WARRANTY BULLETIN

WB25-17

DATE :	July 2025	SECTION :	16 SUSPENSION
EXPIRATION:	July 2027		
SUBJECT :	I-BEAM SUSPENSION RADIUS ROD NUTS REPLACEMENT

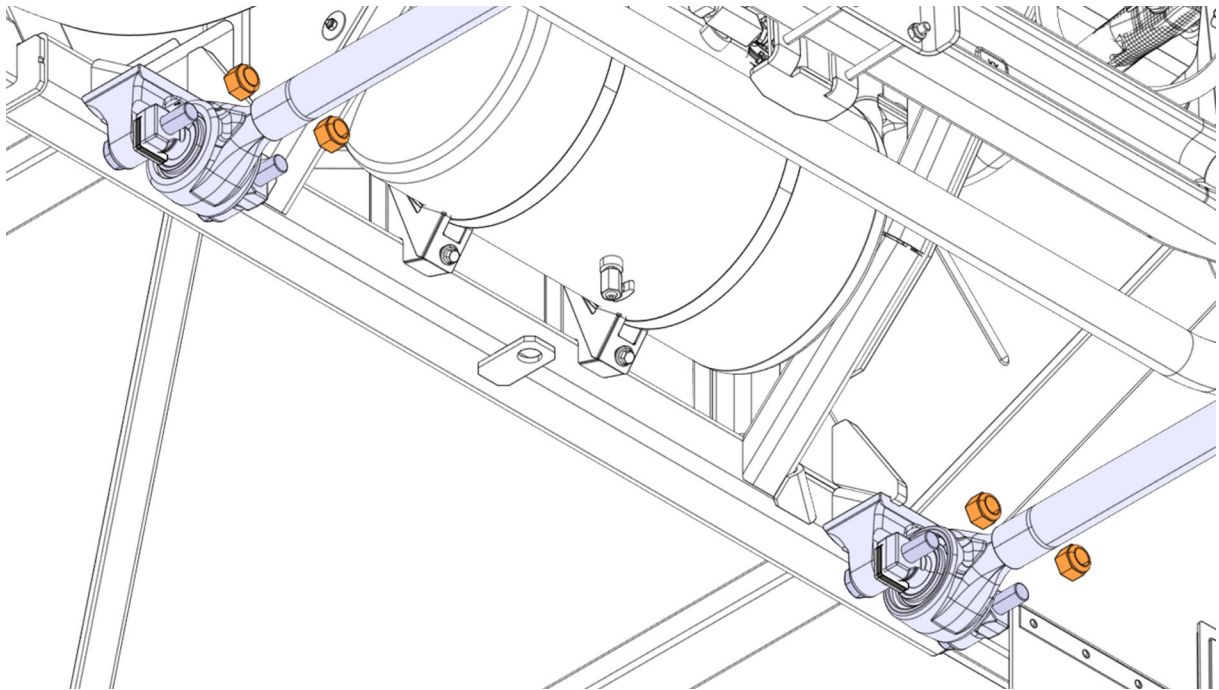
2. Remove and discard the nuts.

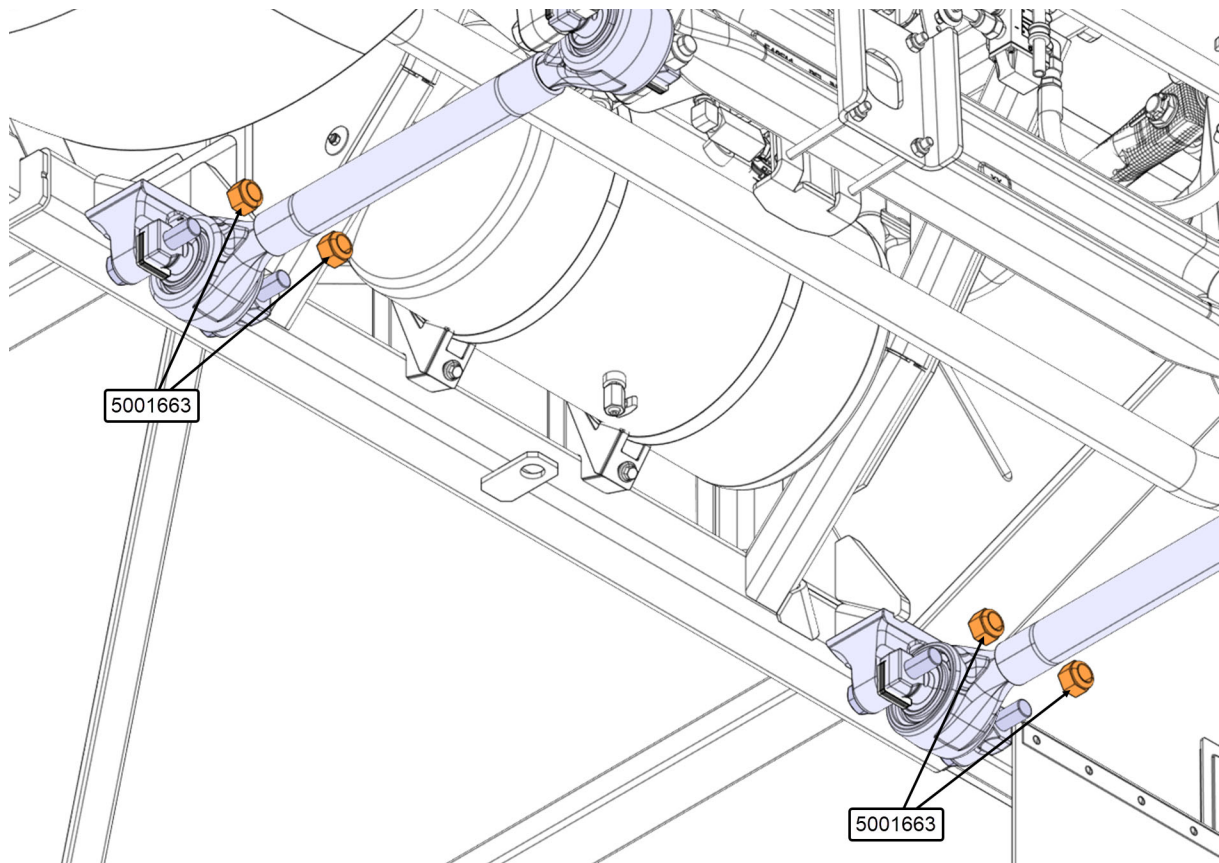
3. Install the new nuts 5001663.

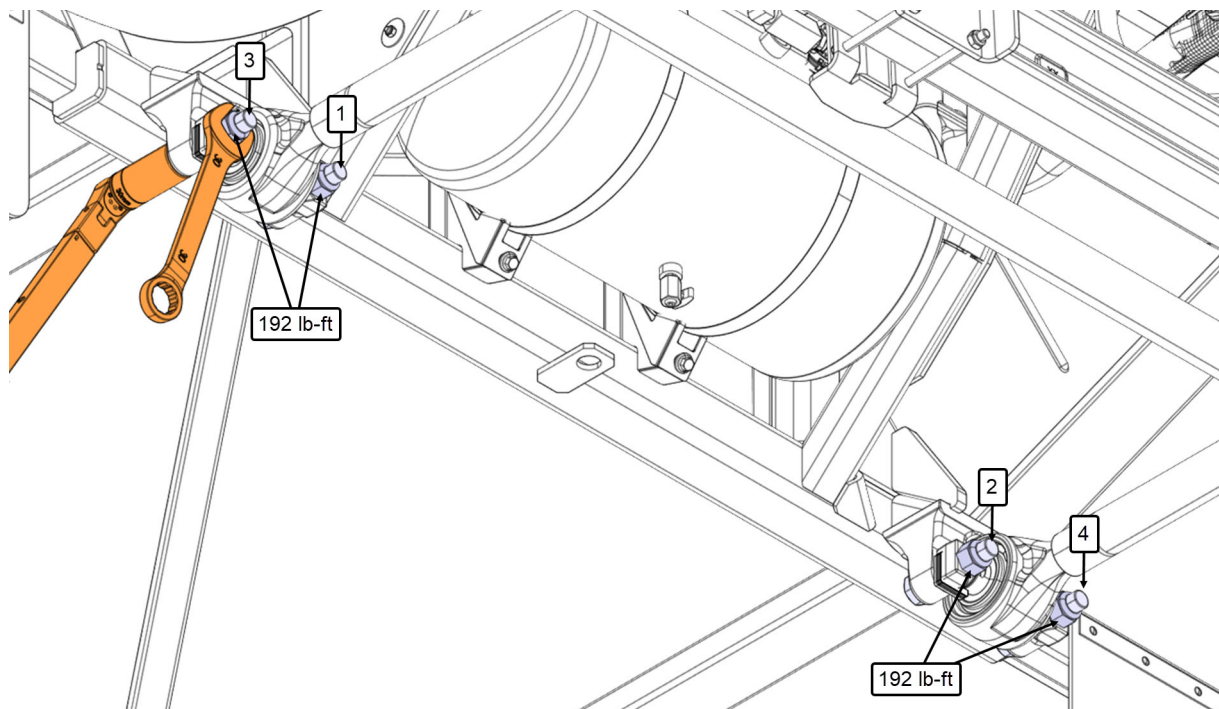
4. Perform the pre-tightening with a torque of 192lb-ft tightening with the sequence 1 to 4.

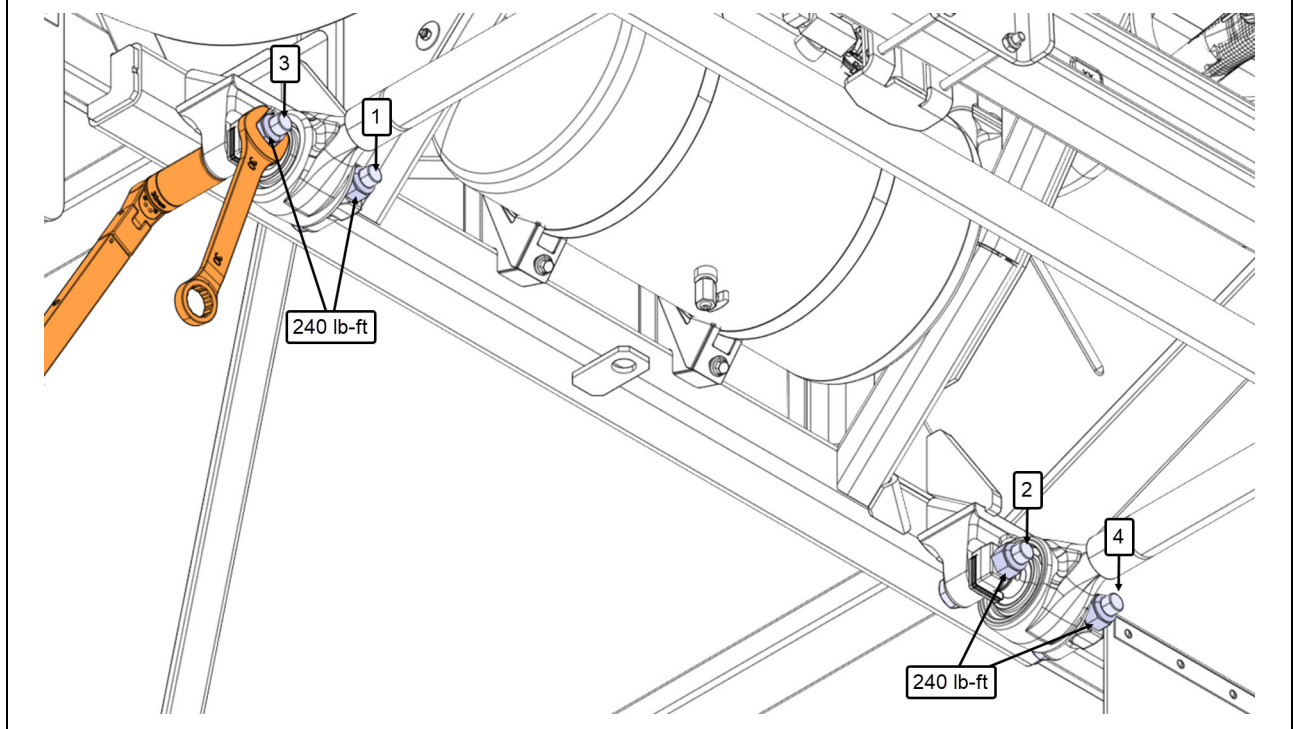
5. Perform the final tightening with a torque of 240lb-ft tightening with the sequence 1 to 4.
